REMARKS

The Office Action mailed July 8, 2004, has been reviewed and the Examiner's comments have been carefully considered. Claims 1, 4, and 7 have been amended. Claims 8 and 9 have been canceled. The drawings and specification have been amended. In view of the foregoing amendments and the reasons that follow, claims 1-7 are pending and are submitted for reconsideration.

Amendments to the Drawings:

FIG. 2

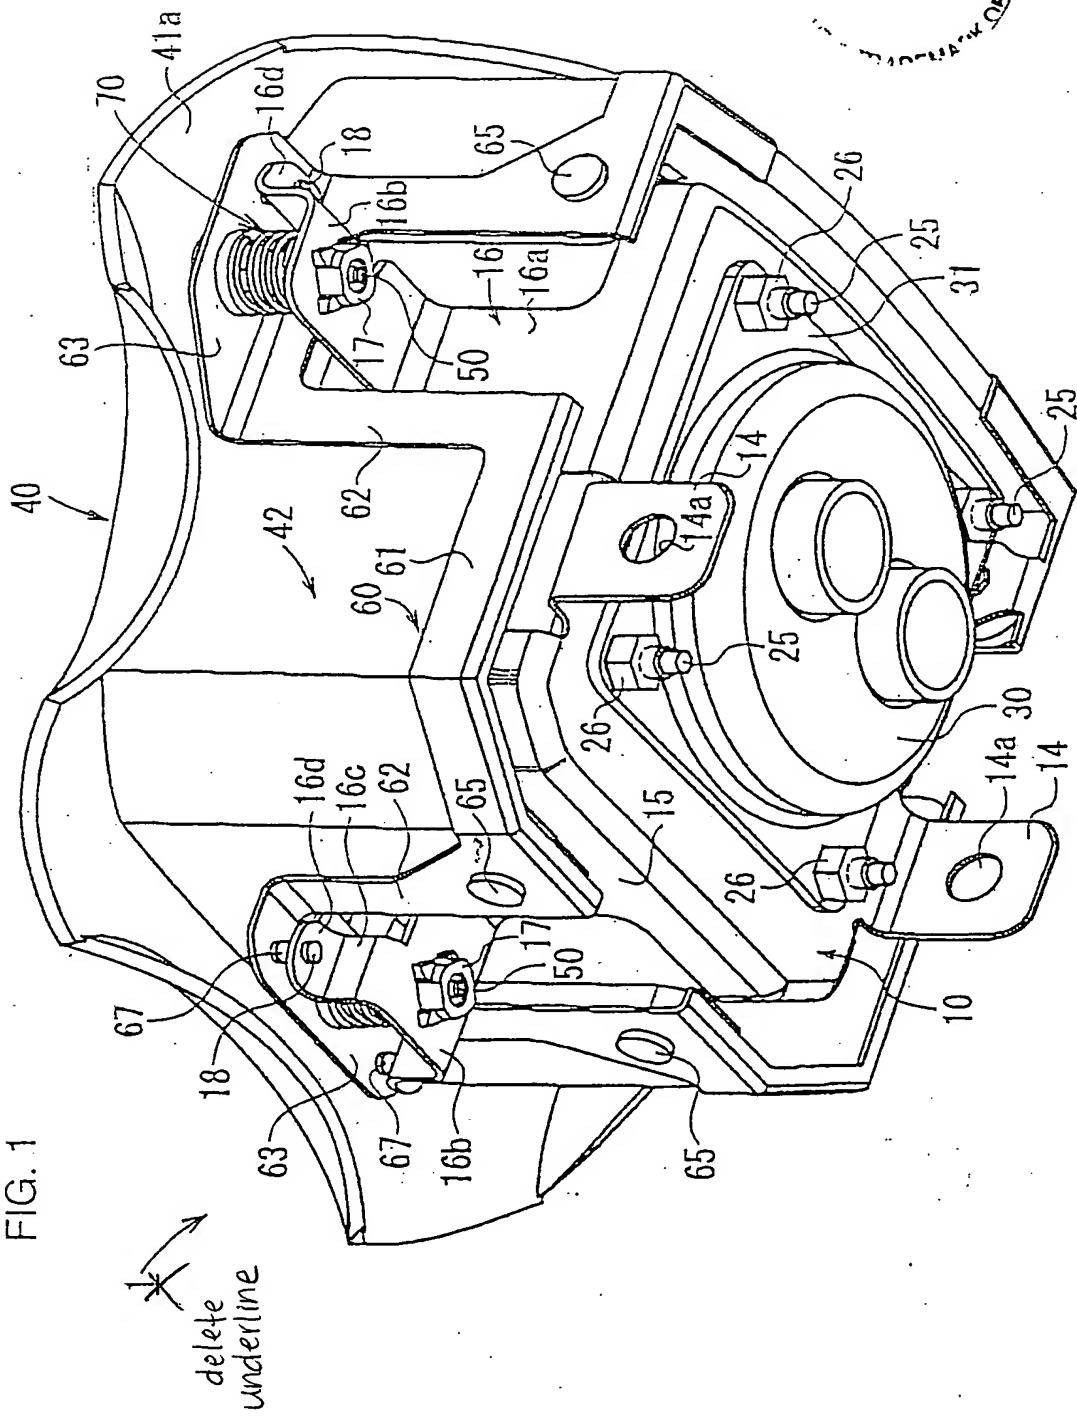
The drawings are objected to because "[c]ontrary to page 7, line 20 part 61 is not L shaped." (Office Action at p. 3.) Figure 2 has been amended to include reference numeral 61. As illustrated in Figures 1 and 2, the base portion 61 clearly includes an L-shaped portion (i.e., the portion that overlaps the outer sides and the end of the projecting portion 42) as explained in paragraph [0033] of the specification. The drawings are objected to because "there is no Figure 5(a) in the drawings." (Office Action at p. 3.) Accordingly, paragraph [0020] in the Brief Description of the Drawings has been amended to refer to Figs. 5(a) and (b). Finally, the drawings are objected to for failing to show "a leaf spring" as recited in claim 4. Claim 4 has been amended to delete the recitation of a leaf spring. In view of the foregoing amendments and remarks, reconsideration and withdrawal of the objections to the drawings is respectfully requested.

Please amend Figures 1 and 2 by replacing the immediate prior versions of the drawing sheets with the replacement sheets of drawings appended to this document. In accordance with 37 C.F.R. § 1.121(d), all changes to the drawings are explained in detail in the remarks section below and shown on the attached annotated sheets.
